5.0 DESIGN FEATURES

CALVERT CLIFFS  
SITE BOUNDARY MAP  
FIG. 5-1

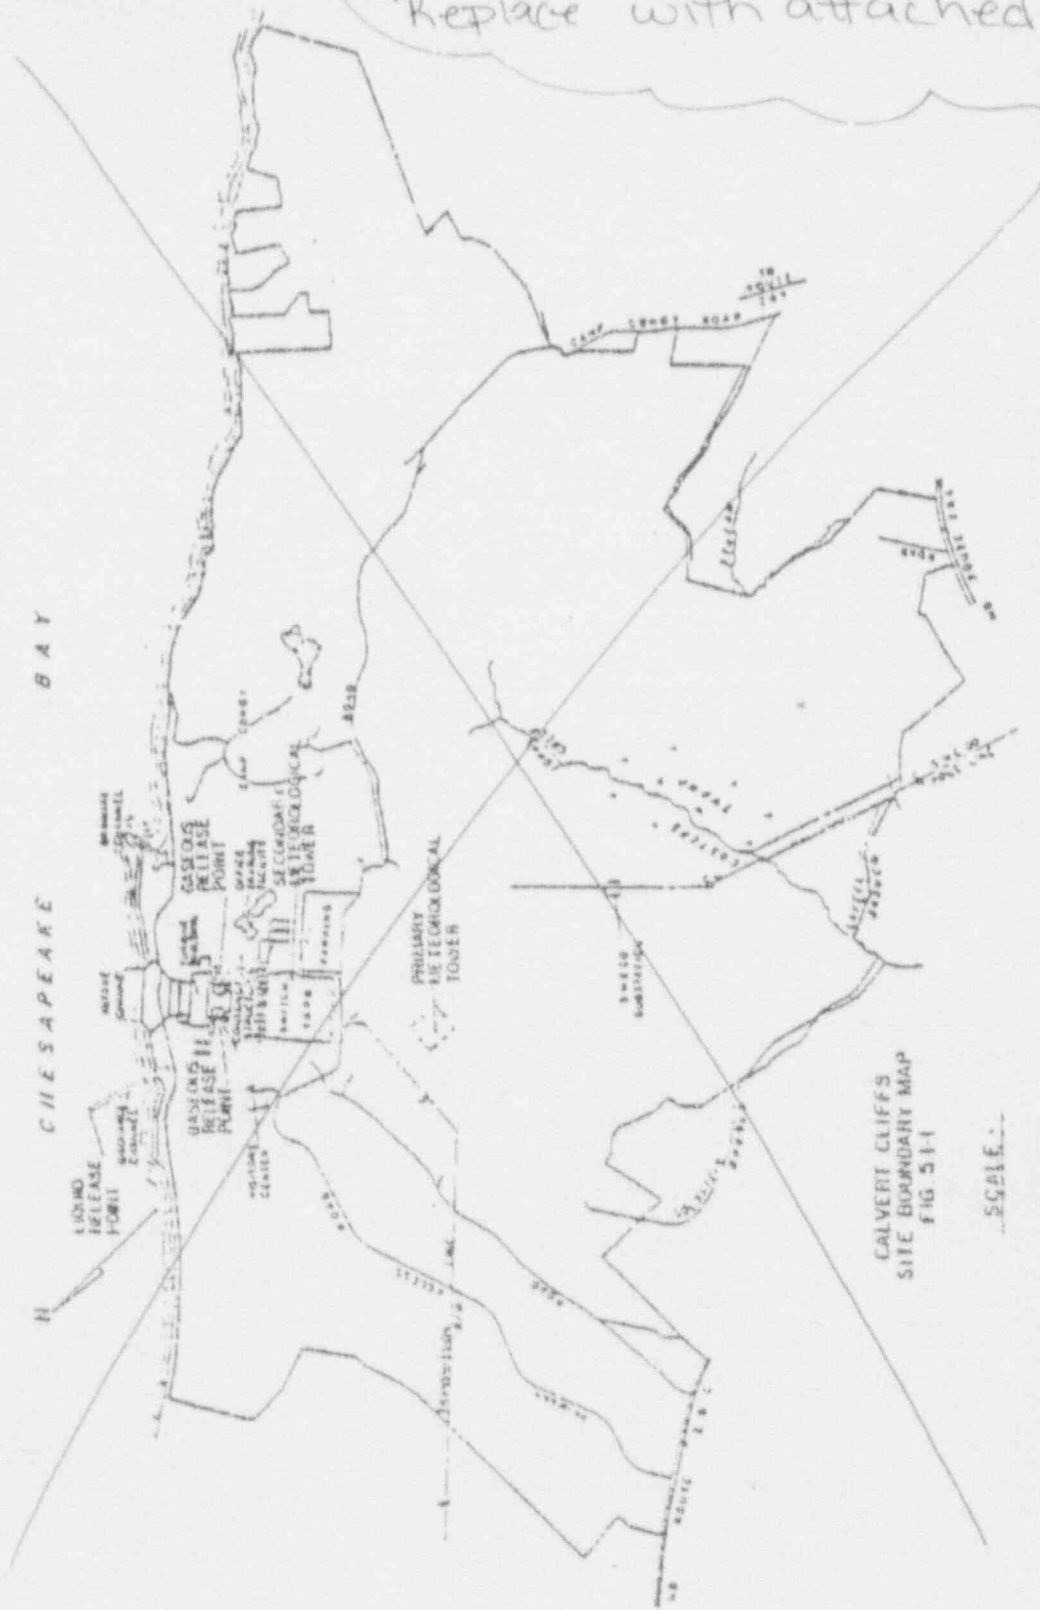
Replace with attached Figure

FIGURE 5.1-2

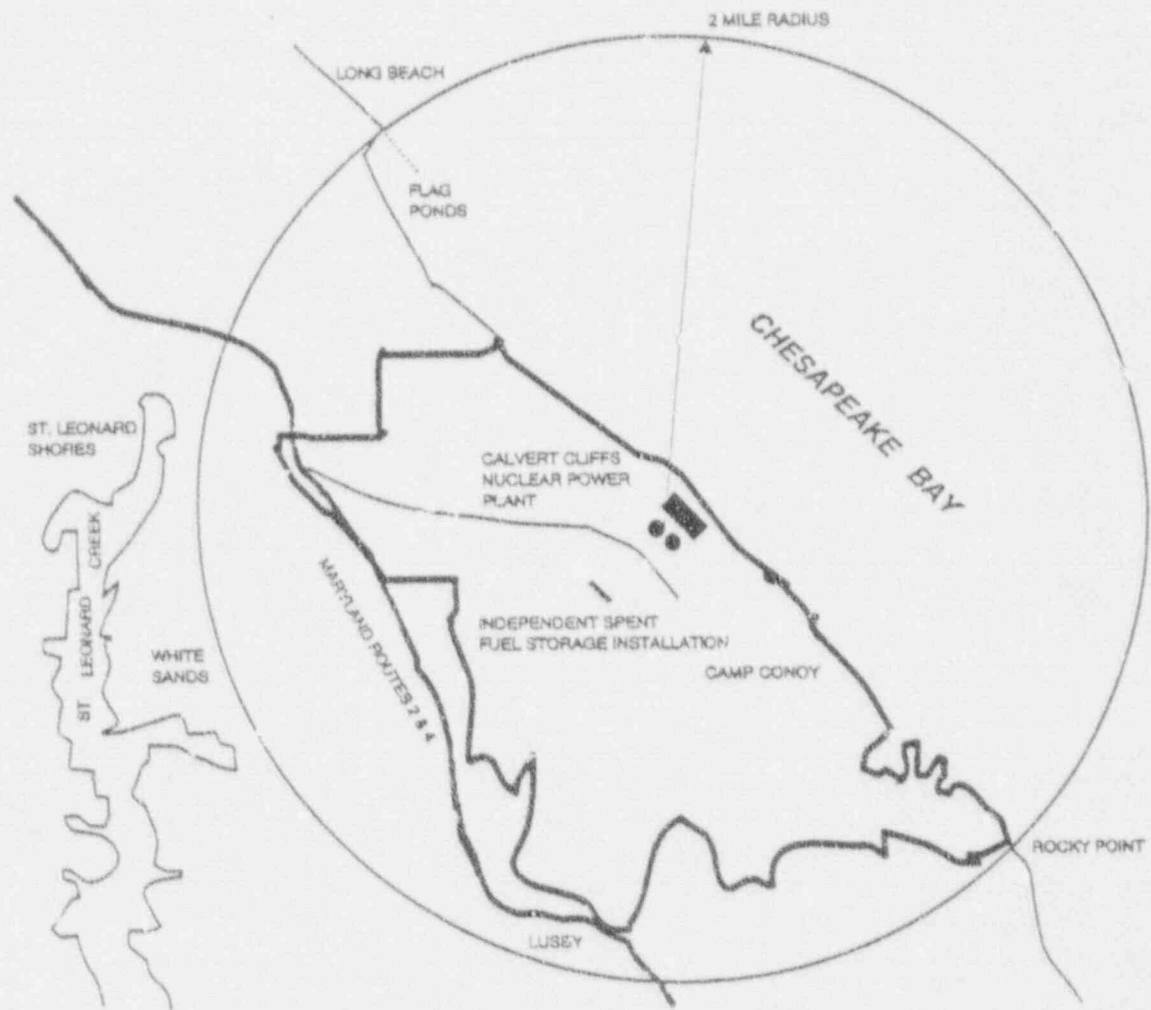
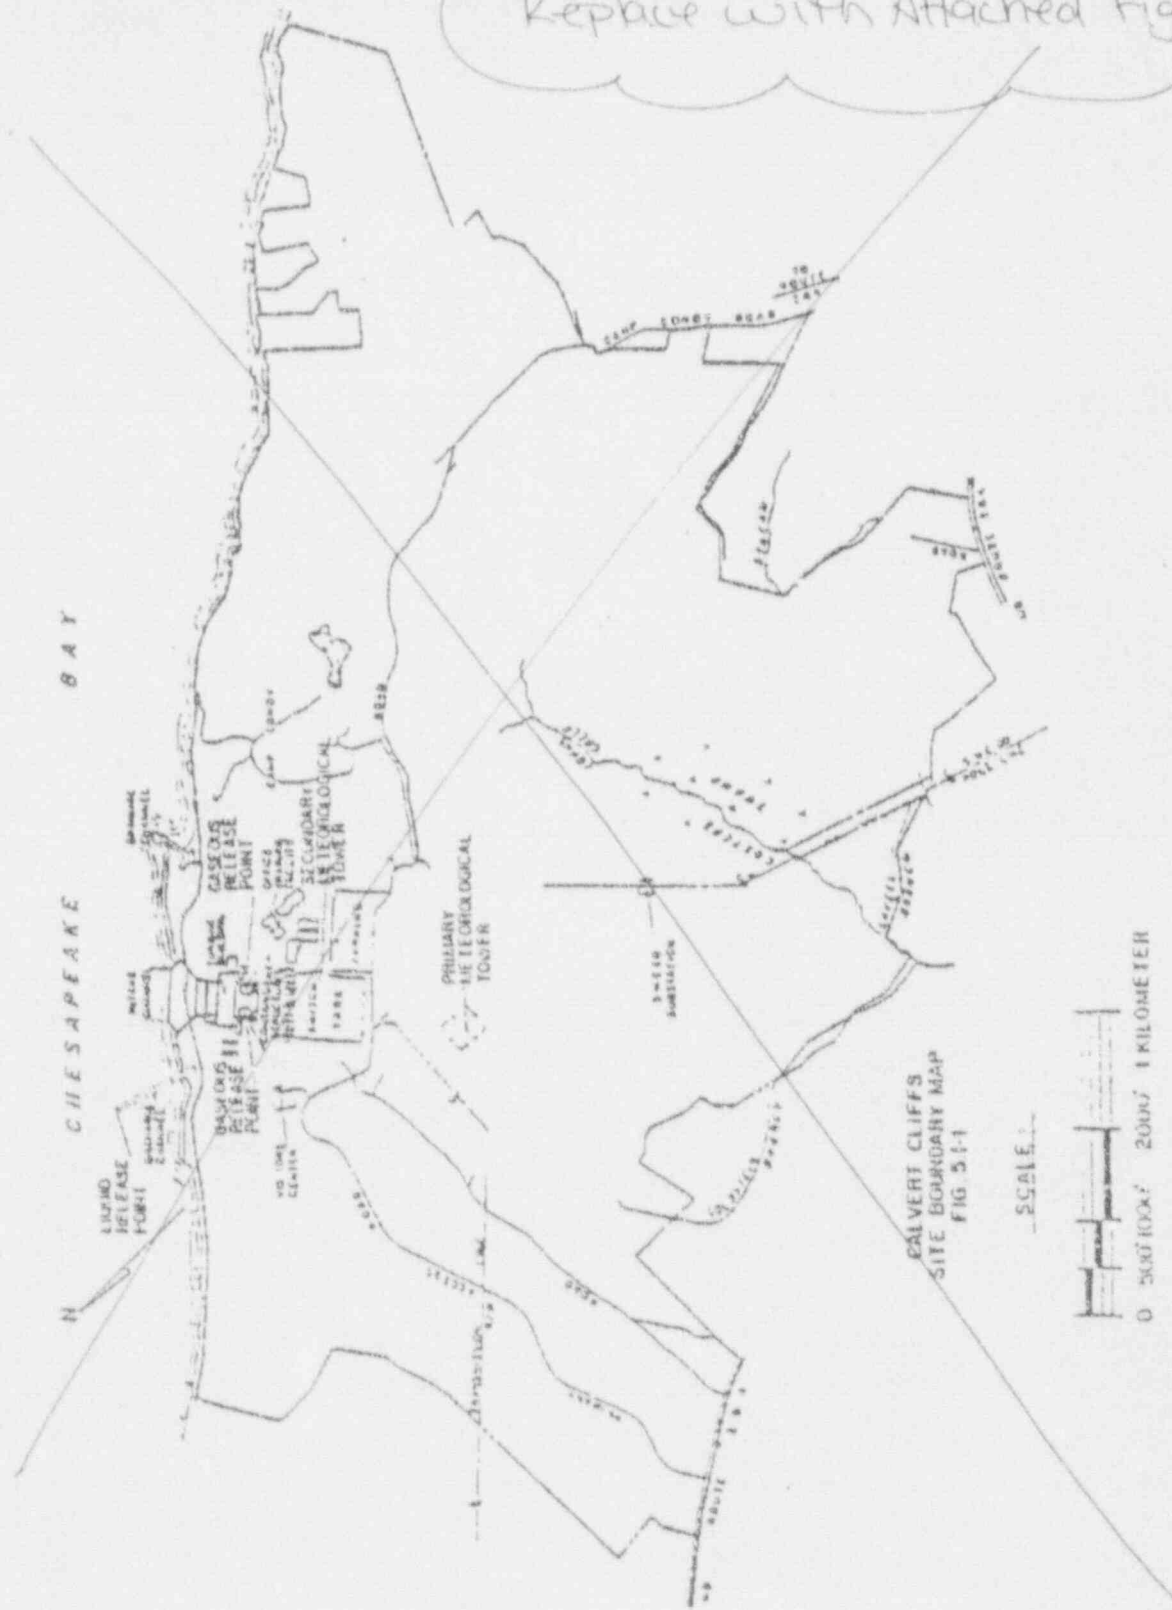
Replace with Attached Figure

FIGURE 5.1-2

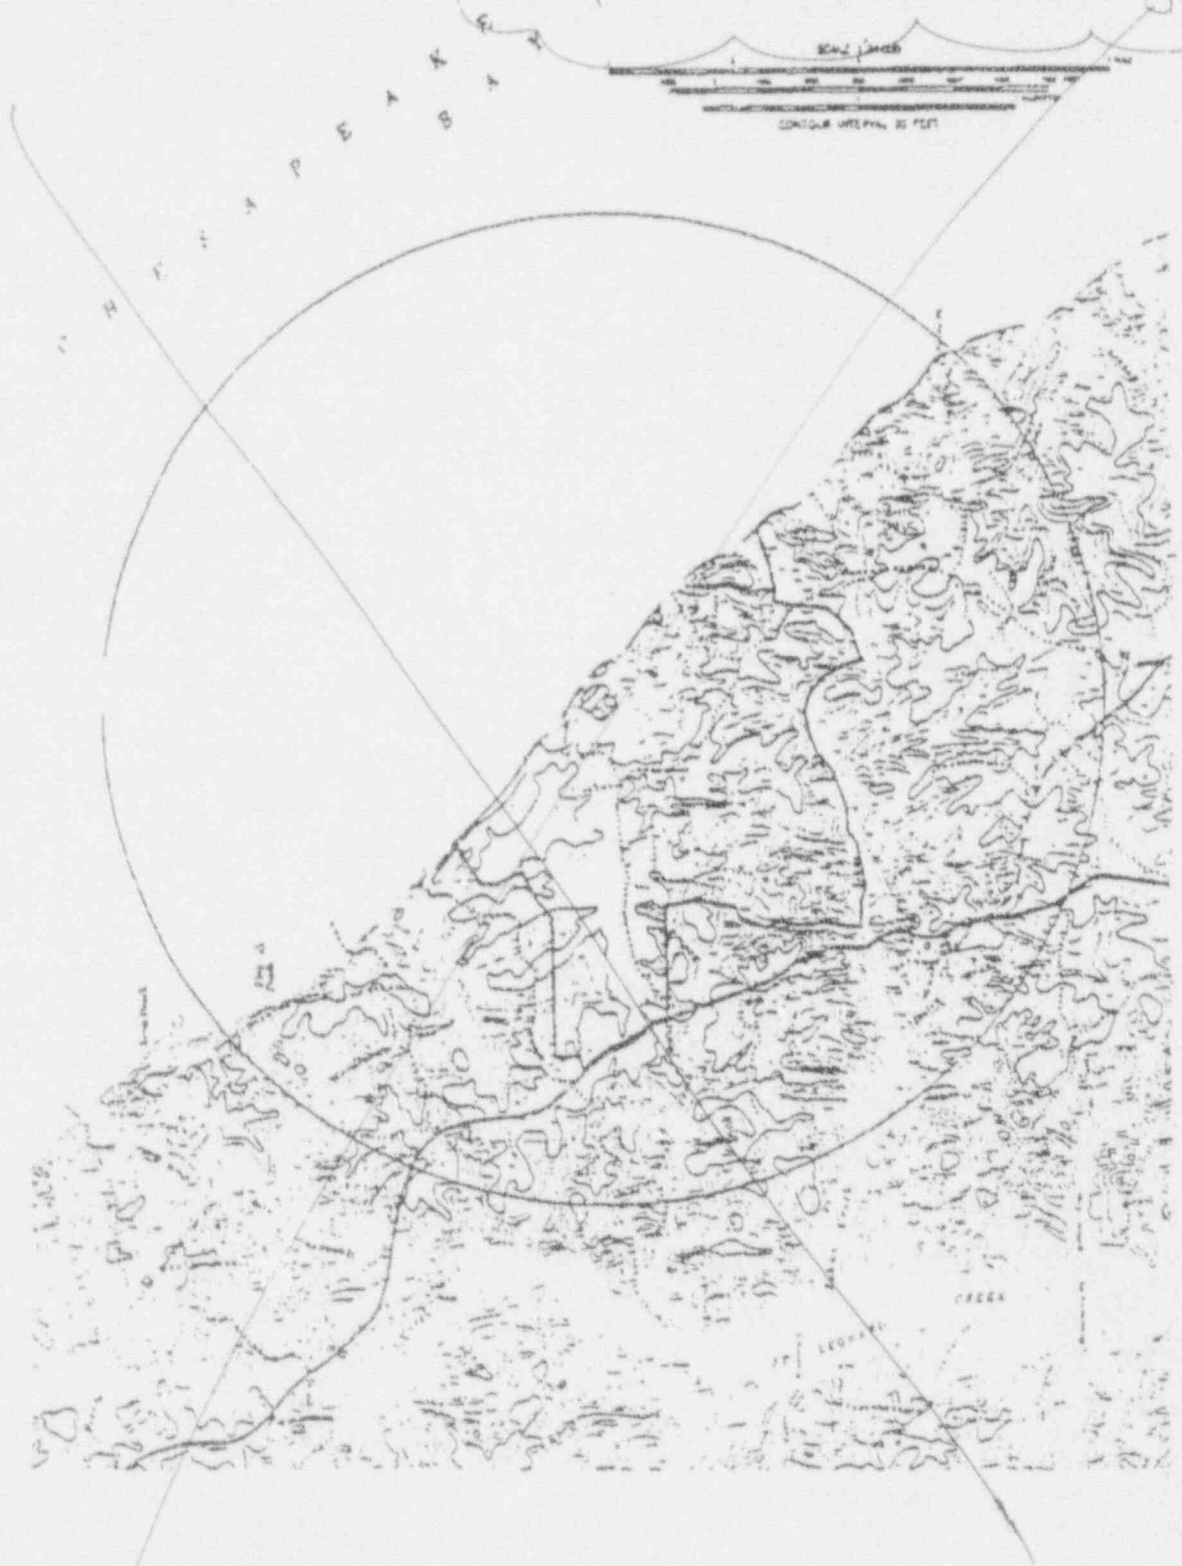
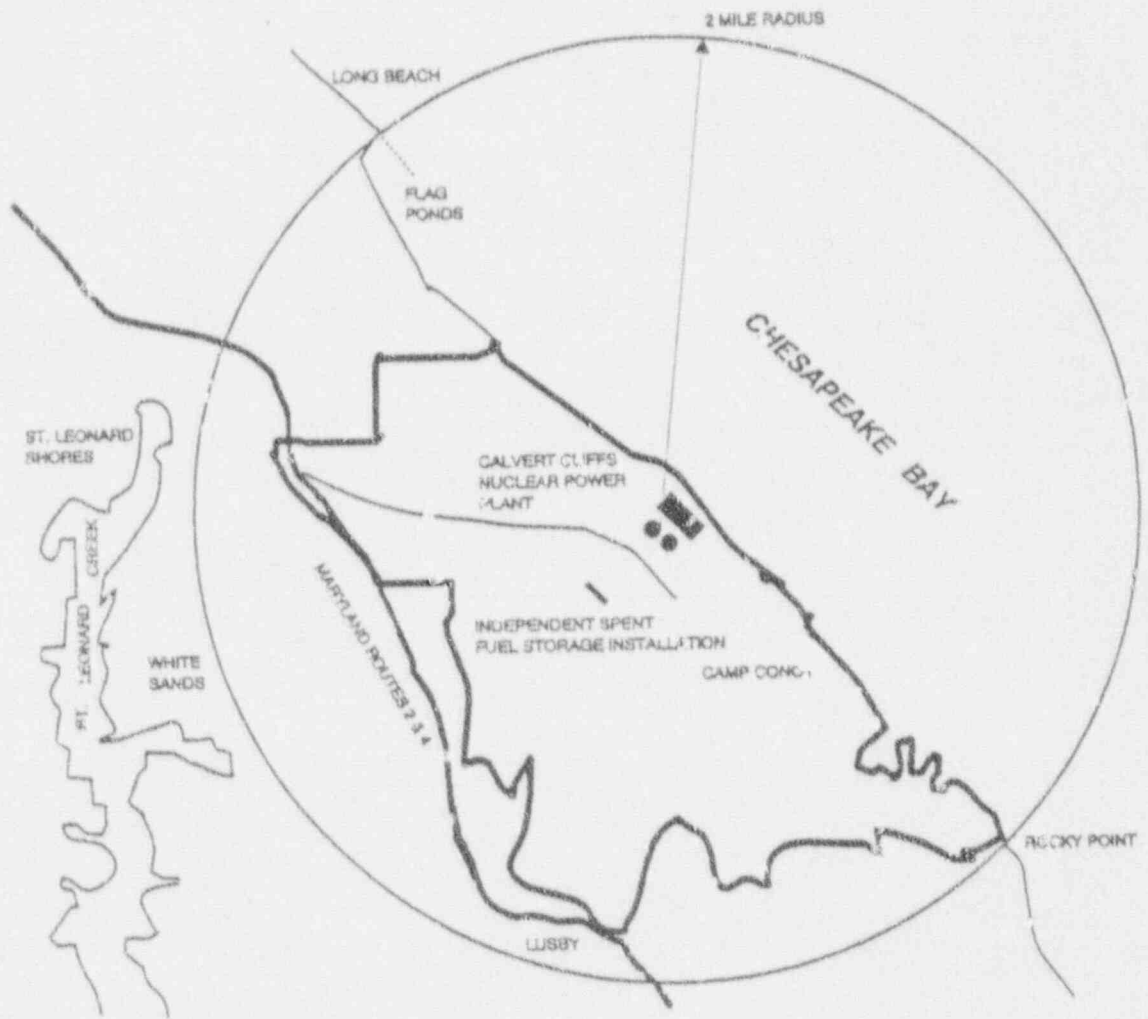
Replace with Attached Figure
